## **7.0 Response to Comments**

### **7.1 Introduction**

The Draft EIR was distributed for public review from January 17, 2019, through March 4, 2019, pursuant to CEQA Guidelines Section 15105. Comments were received throughout the 45-day public comment period in multiple formats. A total of 147 speaker cards, comments cards, email or online comments, and letters were received. Two letters were received after the close of the Draft EIR public comment period (after March 4, 2019).

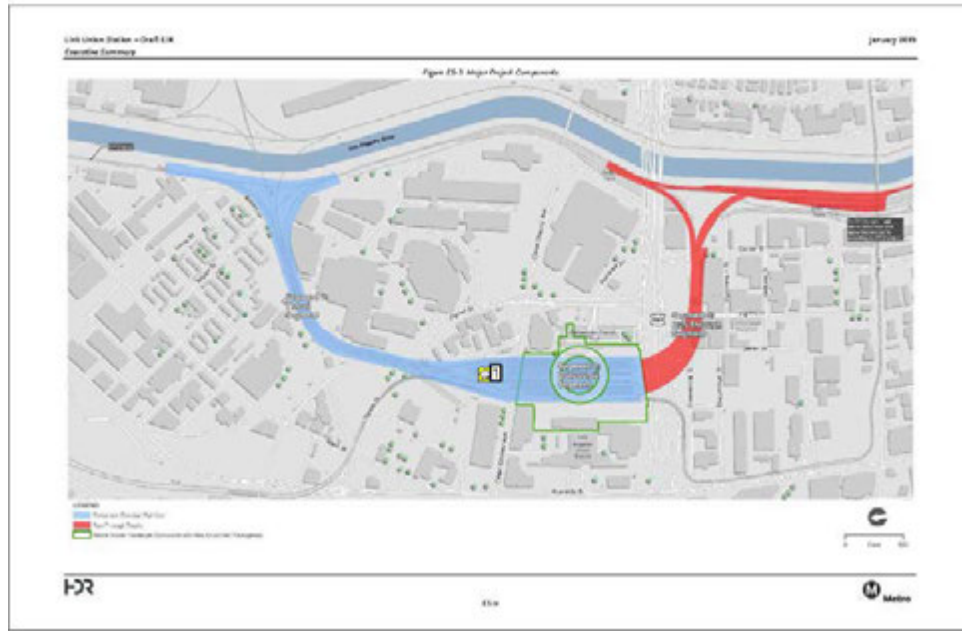
Number: 1 Author: 382146 Subject: Sticky Note Date: 2/19/2019 11:06:04 AM  
please refer to comment on Figure ES-3.

Number: 1 Author: 382146 Subject: Sticky Note Date: 2/19/2019 11:05:48 AM  
would it be possible to superimpose the blue, green, and red limits at 50% transparency onto Figure ES-2? This would provide greater clarity.

AGE 3-1 Refer to response to Comment AGE-3-2.

The intent of Figure ES-2 in the Executive Summary of the Draft EIR is solely to depict the study area boundary and each segment within the boundary, which is similar to, but different than, the major project components shown on Figure ES-3. Figures ES-2 and ES-3 have different purposes and, although overlay of colored information is possible, it will detract from the information intended to be conveyed for both figures.

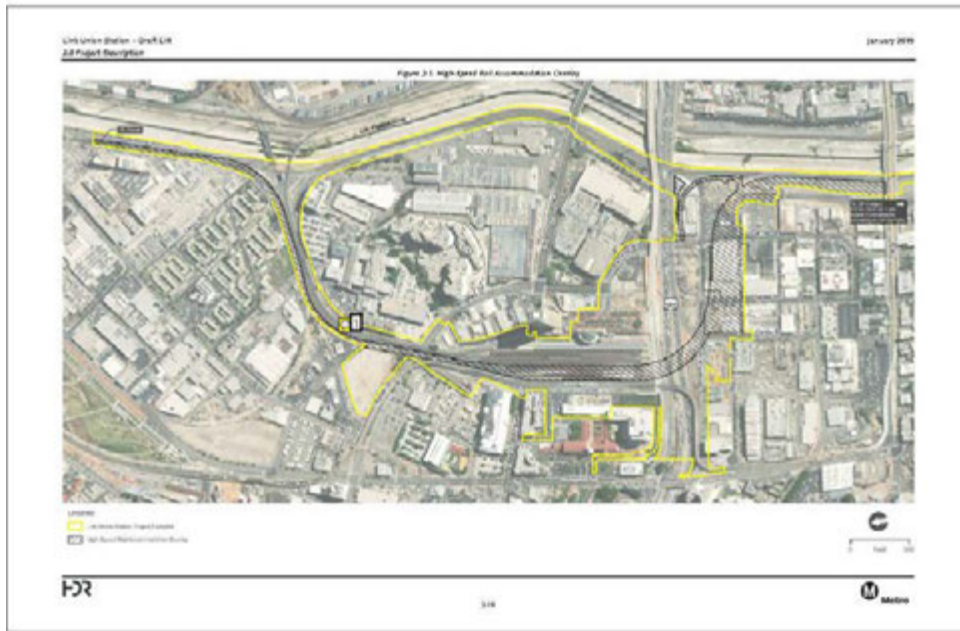
Number: 1 Author: 382146 Subject: Highlight Date: 2/28/2019 4:04:00 PM  
 Same as previous comment.

AGE 3-20

AGE 3-20 See response to Comment AGE 3-19.

AGE 3-21 Addition of the project footprint boundary to this particular figure would not be appropriate because the text in the narrative preceding Figure ES-2 and Figure ES-3 (located in the Executive Summary of the Draft EIR) does not discuss project related impacts that would occur within the boundary of the project footprint.

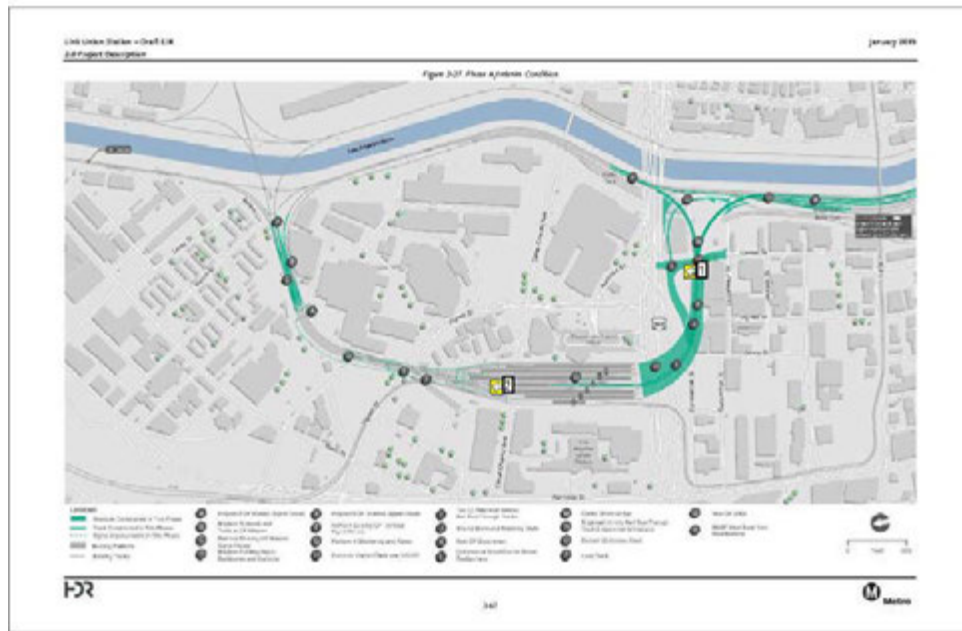
AGE 3-24

AGE 3-24 In response to this comment, the Final EIR Section ES-5 of the Executive Summary has been revised to include a brief summary of the interim, full build-out, and full build-out with HSR conditions as follows:

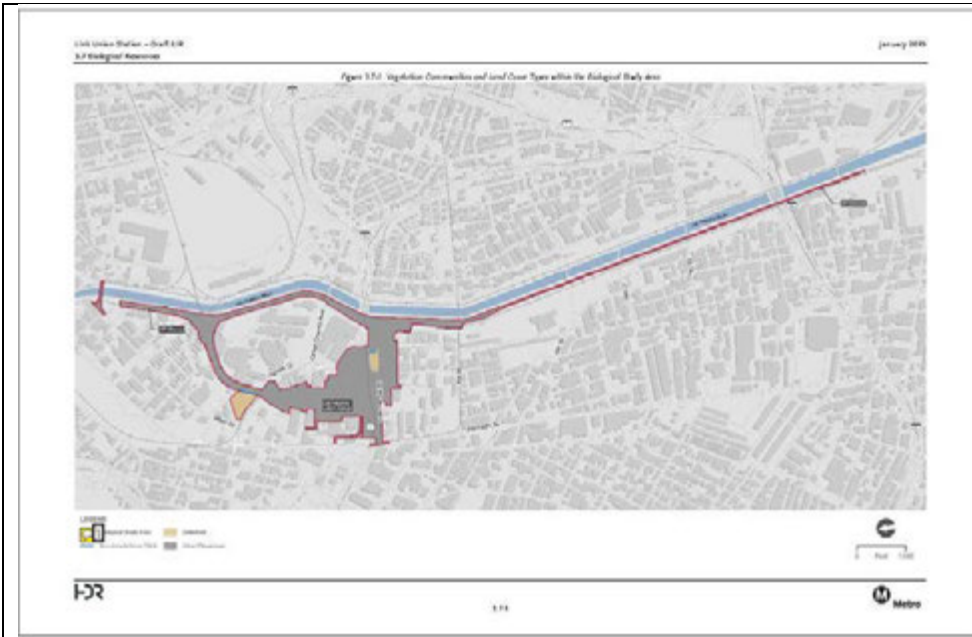
Number: 1 Author: 382146 Subject: Highlight Date: 2/25/2019 11:09:33 AM  
 Please refer to comments on page 3.4-11 (PDF page 333) regarding US-101 motorists views.

AGE 3-39

AGE 3-39 See response to Comment AGE 3-38.

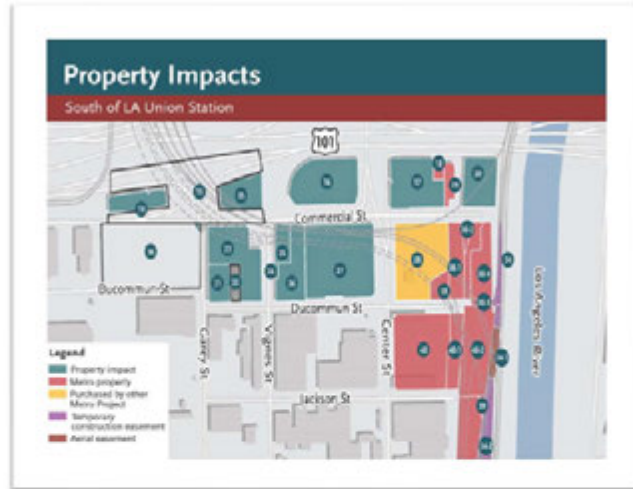
<p>My unreinforced masonry building was built in 1926 and is susceptible to ground vibrations. Grout falls out when heavy trucks pass by. I fear the constant ground vibrations from the Link US trains could deteriorate my old brick walls creating a danger to people in the building or on the side walk. The Draft EIR states that there are no fragile or extremely fragile structures in the area (pages 3.6-17 – 3.6-18). I would like to know how this was determined and what the definition of a fragile structure is.</p>			
<p><b>EMF – Business and Health</b></p>			<p>IND 109-8</p>
<p>As tested by Booz Allen, the Metrolink trains produce a substantial EMF signal in the audio range that spread at least 100 feet and would affect my sound operations. It is unclear from the Draft EIR if there is either or both audio EMF propagation or higher frequency EMF. It is also unclear therefore if either of these will affect our health or my business operations that are EMF sensitive. As stated in the Draft EIR (Section 2.1.2 on page 2.6), Metrolink trains will likely use these tracks for particular routes and bring their confirmed EMF signals to the area.</p>

<p><b>Fragile or Extremely Fragile structures</b></p>	<p>IND 109-7</p>	<p>IND 109-7 According to the 2018 FTA/FRA manual, it is extremely rare for vibration from train operations to cause substantial or even minor cosmetic damage. Even for fragile historic buildings, damage is unlikely except where the track is located very close to the fragile structure in question. The FTA/FRA manual (Table 7-5 on Page 186) provides structural damage criteria for four different structure types. Review of the structure at 611 Ducommun Street by a structural engineer would be needed to specifically assign the building to one of these categories, but conservatively assuming that it is building/structural Category III “Non-engineered timber and masonry buildings,” the vibration damage impact criterion is approximately 94 VdB. Predictions of project vibration at the structure indicate that trains operating would result in 51 VdB, which is less than the damage criterion. Therefore, building damage due to operational vibration from the proposed project considered in the Draft EIR is not anticipated. The likelihood for building damage as a result of the Final EIR project is further reduced due to the modified run-through track alignment and presence of intervening buildings along Commercial Street.</p>
